SECTION 009113 – ADDENDUM ONE

- A. Project Name: 22034.03 Meridian High School Baseball/Softball
- B. Owner: Meridian Public School District, 1019 25th Avenue, Meridian, MS 38391
- C. Architect: Dale | Bailey, an Association, One Jackson Place, Suite 250, 188 East Capitol Street, Jackson, MS 39201-2100
- D. Architect Project Number: 22034.03
- E. Date of Addendum One: 28 March 2023

Addendum One
Meridian High School
Baseball/Softball
Meridian, Mississippi

Meridian High
Baseball Field
E-000
ELECTRICAL LEGEND

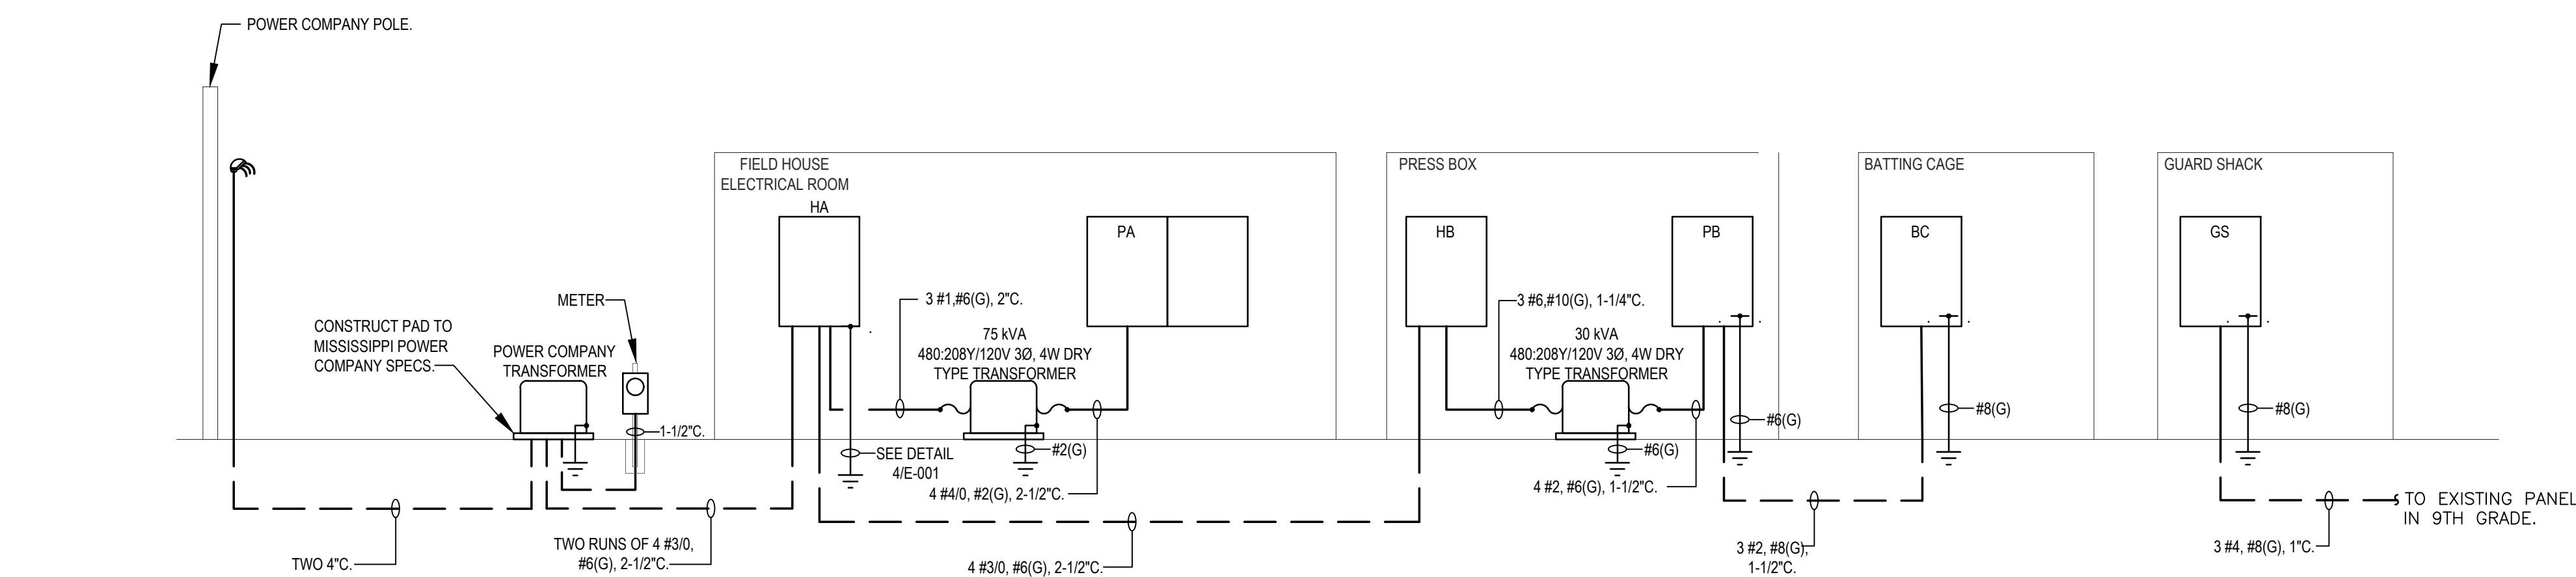
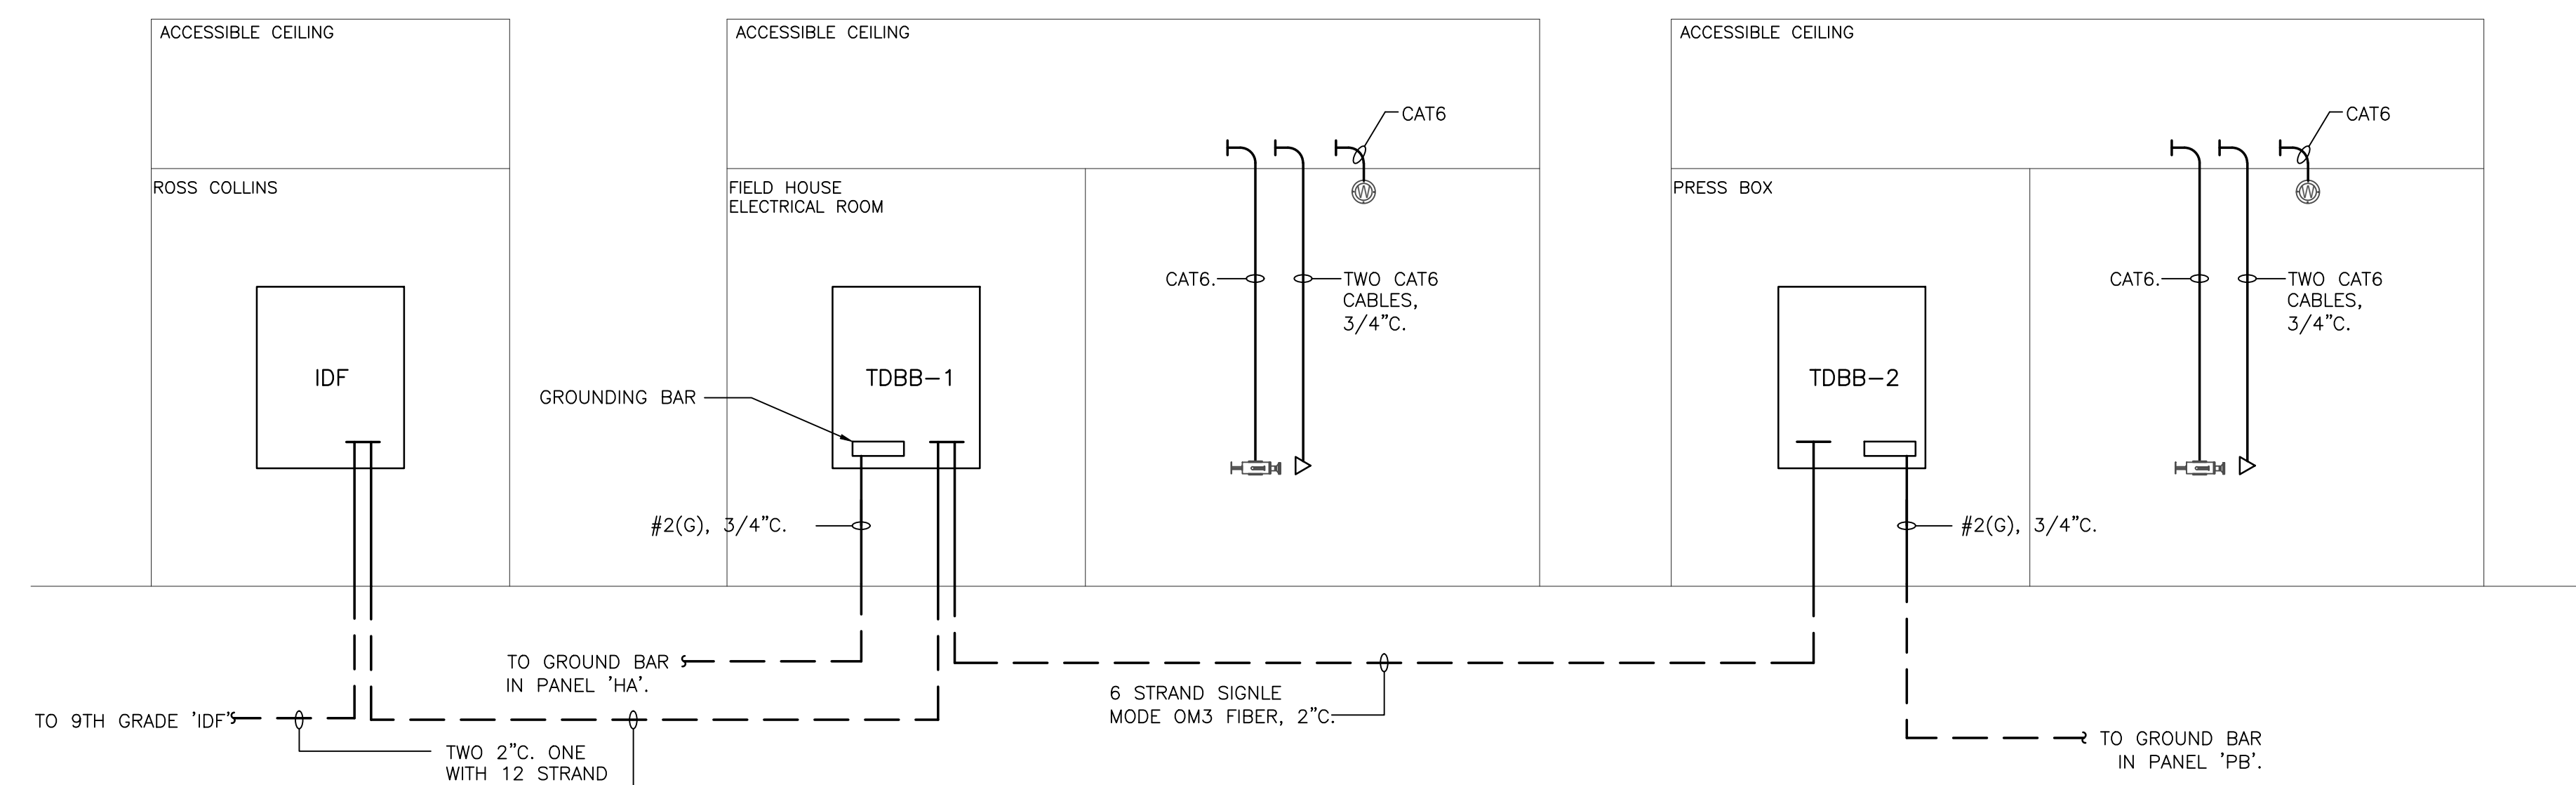
- A. Electrical Sheet E-000 – ELECTRICAL LEGEND. Delete this sheet in its entirety and replace with the attached. Added note for Weatherproof Outlet.
- B. Electrical Sheet E-004 – PANEL SCHEDULES. Delete this sheet in its entirety and replace with the attached. Added circuit for pitcher's mound outlet.
- C. Electrical Sheet E-201b – OVERALL LIGHTING PLAN – ALT 001. Delete this sheet in its entirety and replace with the attached. Added Weatherproof Outlet location.
